Major Site Plan Application

RE: Major Site Plan Application - Resubmittal
H2OBX RV Resort
Currituck County, North Carolina

POST DEVELOPED DRAINAGE AREA MAP
H2OBX RV & WATERPARK RESORT
H2OBX, LLC
CURRITUCK COUNTY
POPLAR BRANCH TOWNSHIP
NORTH CAROLINA

EXISTING CONDITIONS/DEMOLITION PLAN

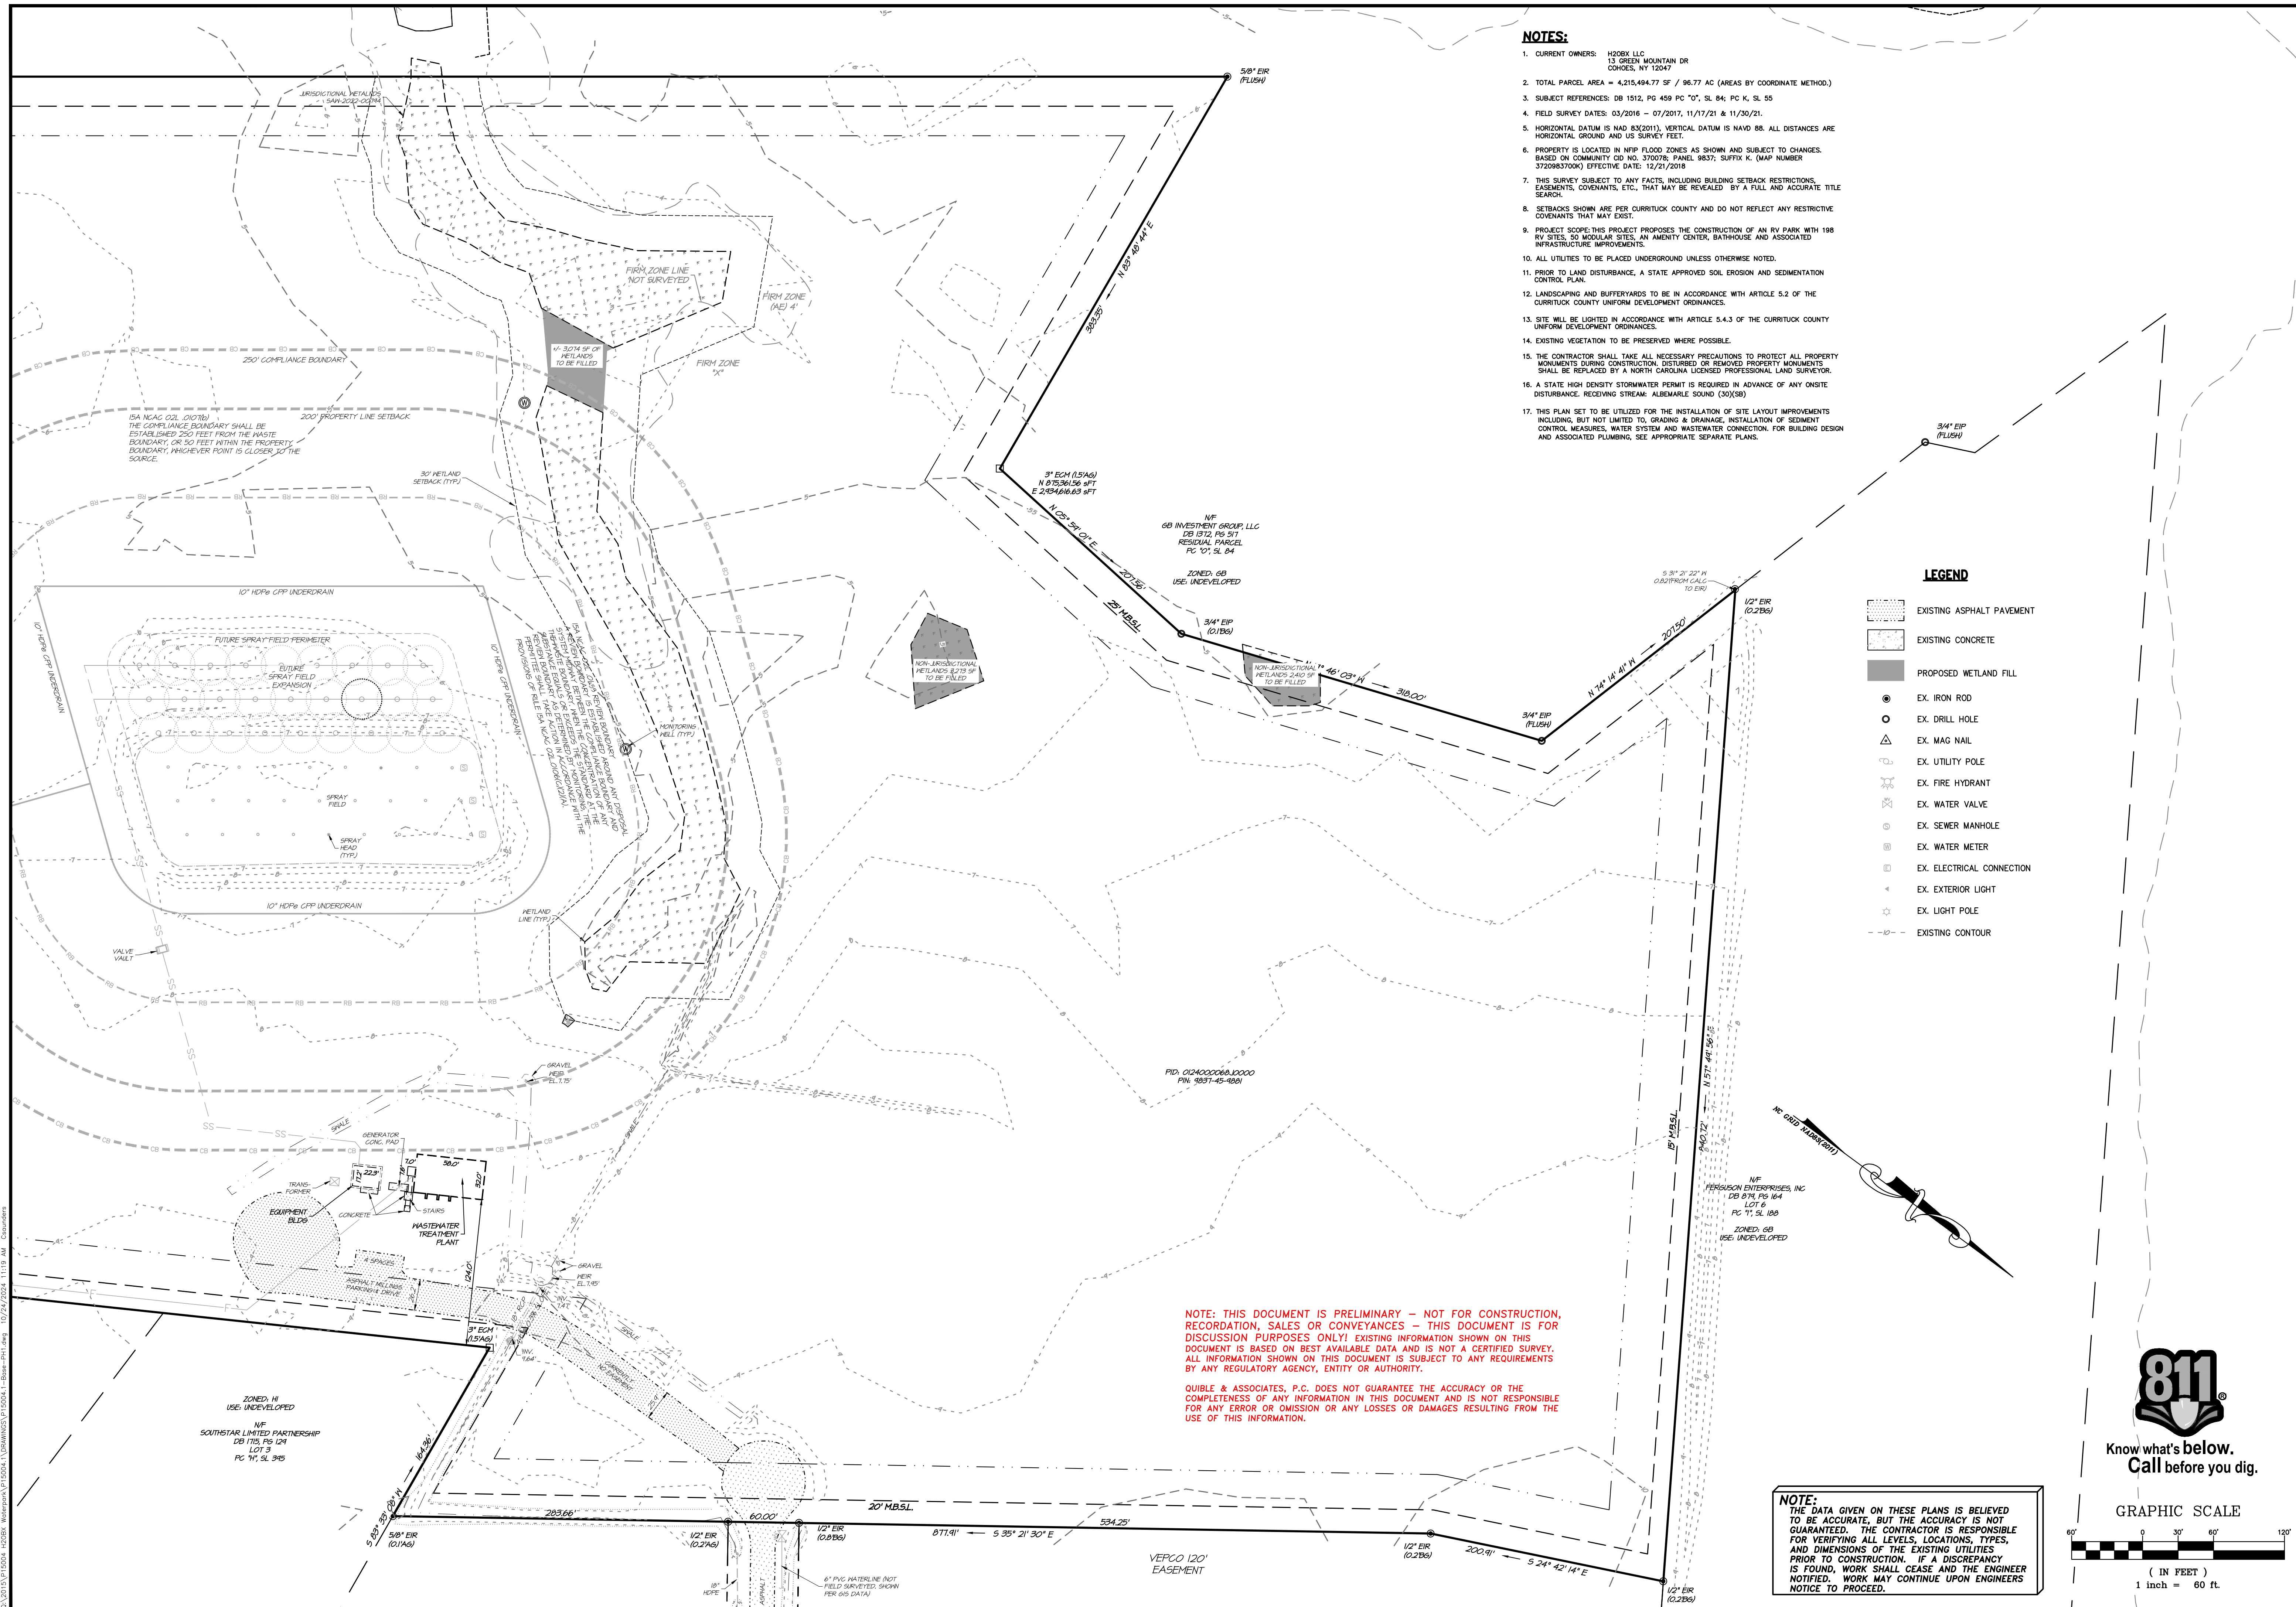
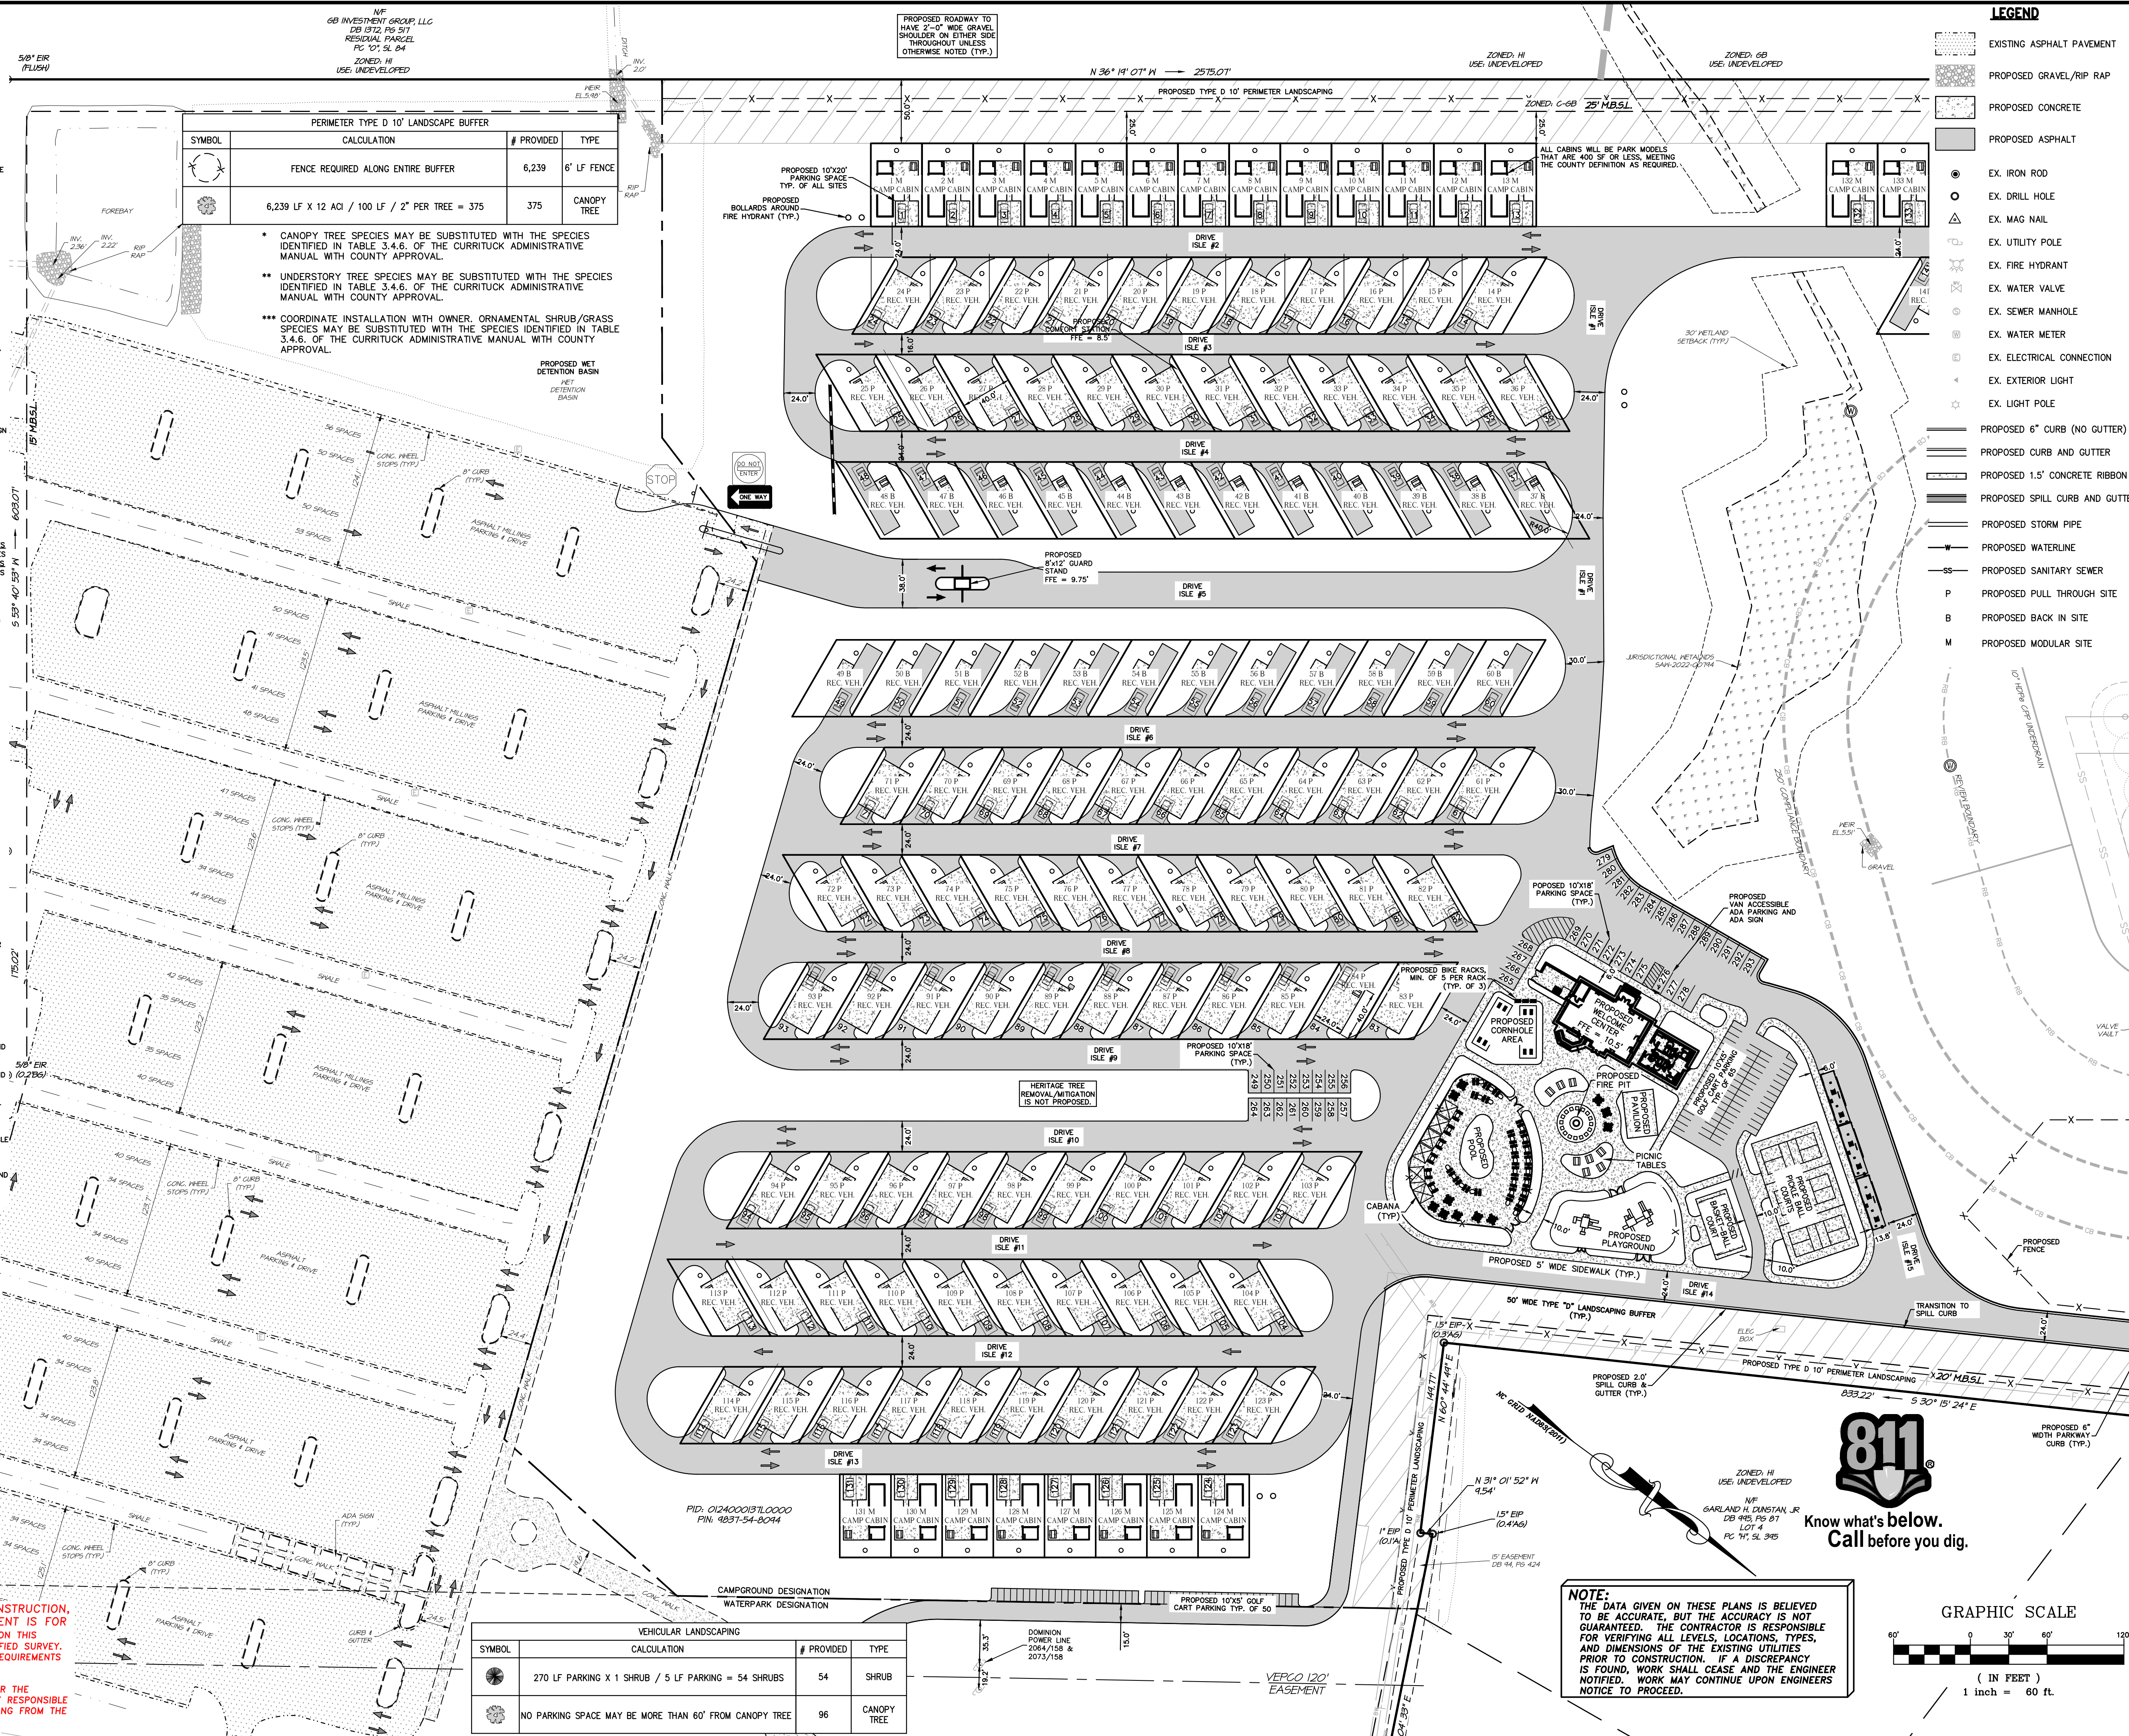
4. It is unclear which areas are going to be demolished in the existing conditions plan. There are no areas that match the indicated hatch. Please verify which areas will be demolished and quantify the items that are to be demolished. *Acknowledged. This is the entire extents of the “construction debris, gravel, and asphalt millings” as shown on existing conditions Sheet 2 called out to be removed. The removal hatch has been added.*

15. Please show entirety of forebay and main pool for the wet detention basin. *Acknowledged and updated.*
16. For non-jurisdictional wetlands, it is recommended that they are filled if proposed construction will be done within the wetland. *Acknowledged. Wetlands fill is now called out on the existing conditions sheet.*
